Docket Item # 3
BAR CASE # 2013-0027

BAR Meeting
March 6, 2013

ISSUE: Alterations (Window Replacement)

LOCATION: 123 Cameron Mews

Figure 1: Section Detail: Jambs

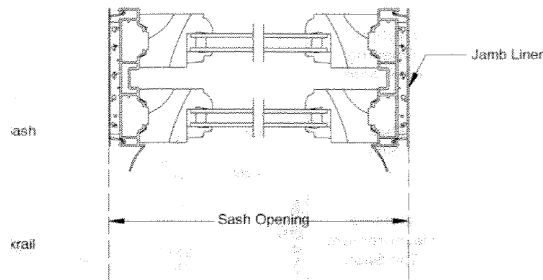
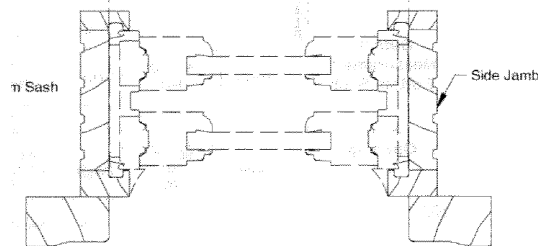
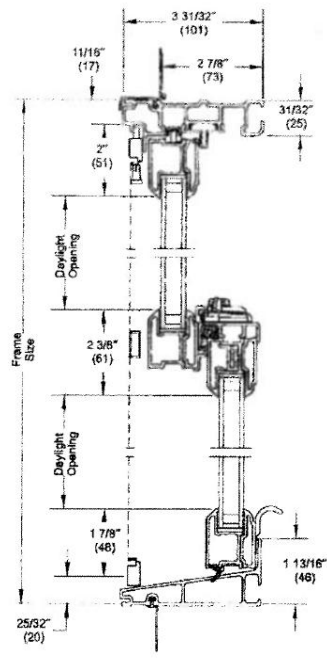
As the proposal for the subject townhouse did not meet the current criteria set forth in the *Window Policy*, Staff was unable to administratively approve an application for the proposed fiberglass insert and aluminum clad wood replacement windows. In considering the subject property, Staff finds that it is more closely related to the post1975 multi-story townhouses found throughout the historic district where Staff can administratively approve both aluminum clad wood and Fibrex composite windows. Further, although the proposed fiberglass windows are categorized as "insert" windows, it has been presented to Staff by the Window Man company salesman, that the current fiberglass technology has enabled the window manufacturer to develop a much narrower window jamb width, thus reducing the visual impact to the glazing proportions which is typically found with an aluminum-clad wood or vinyl insert window. Staff has provided section details of the jambs, and header/check rail and sills for the Boards review in Figures 1 & 2 below.

Staff recommends approval of the fiberglass, SDL insert windows and the aluminum-clad window and door with the condition that the final window specifications are approved by BAR staff and the windows should still meet all other applicable requirements of the Board's *Window Policy* and the Alexandria Replacement Window Performance Specifications #2-9.
